State of Ohio Environmental Protection Agency

December 31, 2007

**Re: Outstanding Post Closure Care  
Financial Assurance Issues**

**Attachment A**  
**Rule Analysis for Leachate Line Cleaning**

Hull & Associates, Inc.  
CINCINNATI, OHIO  
TREMONT LANDFILL COMPANY, INC.  
TREMONT LANDFILL  
REVISED TOP/ PHASE I  
WASTE GRADING PLAN

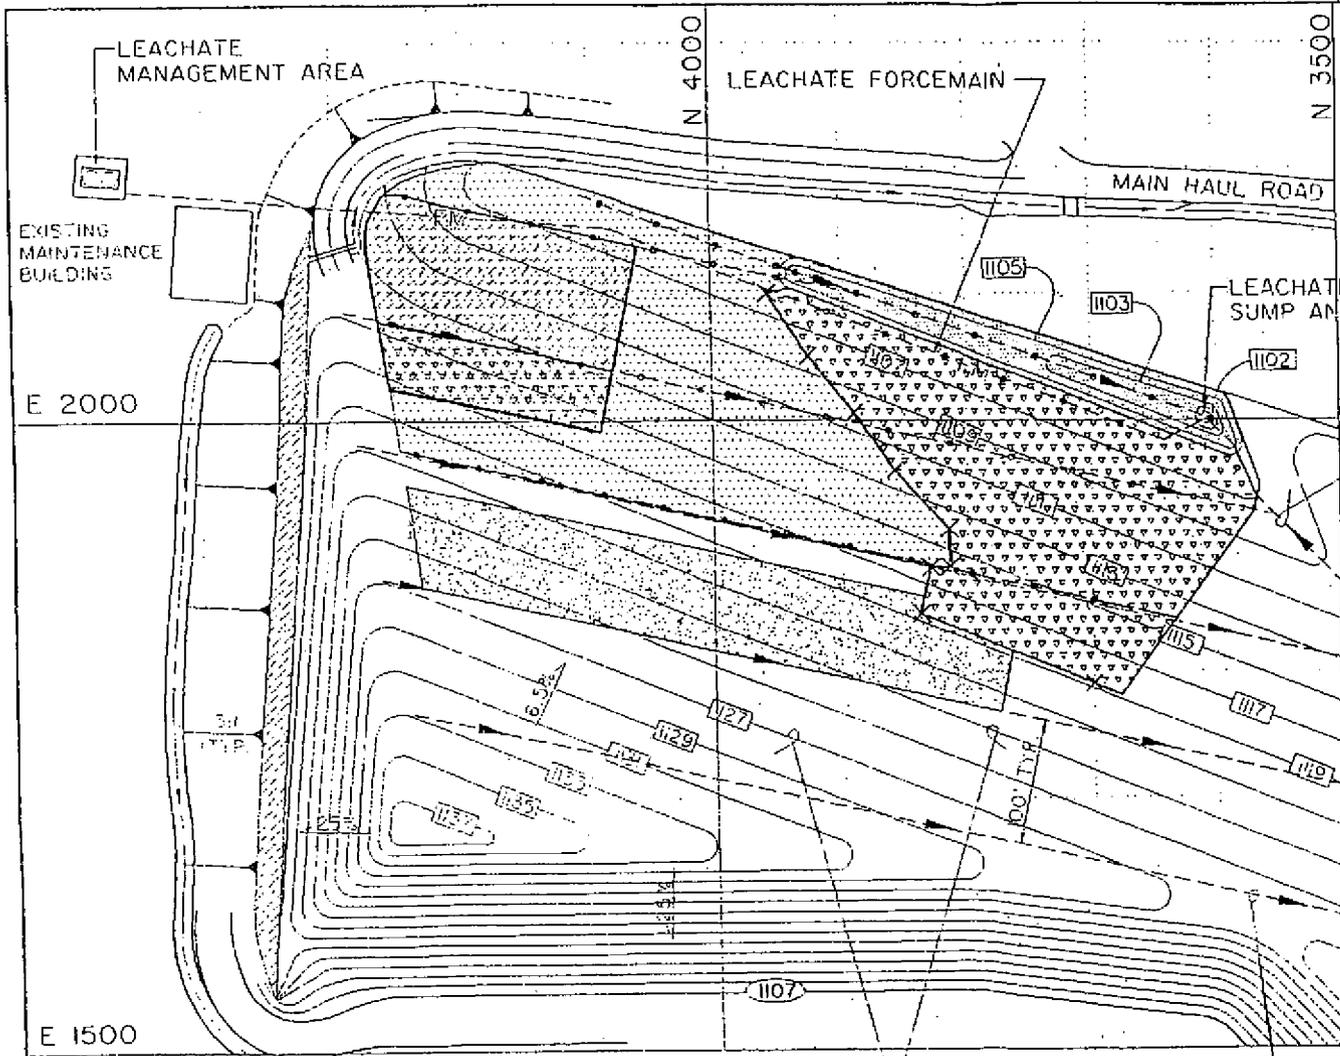
Given this information, SWDO/DSIWM staff conducted a rule analysis and was able to determine that cleaning of leachate lines was a requirement of the solid waste rules effective 1990 and therefore would be a requirement throughout the PCC period. A copy of this rule analysis is enclosed for your information and use (Attachment A). **Please revise your PCC cost estimate to provide for inspection, cleaning and maintenance of all leachate collection lines at the landfill. Please ensure that all linear footage of collection piping shown on the drawings included (Attachment B) is accounted for in the cost estimate.**
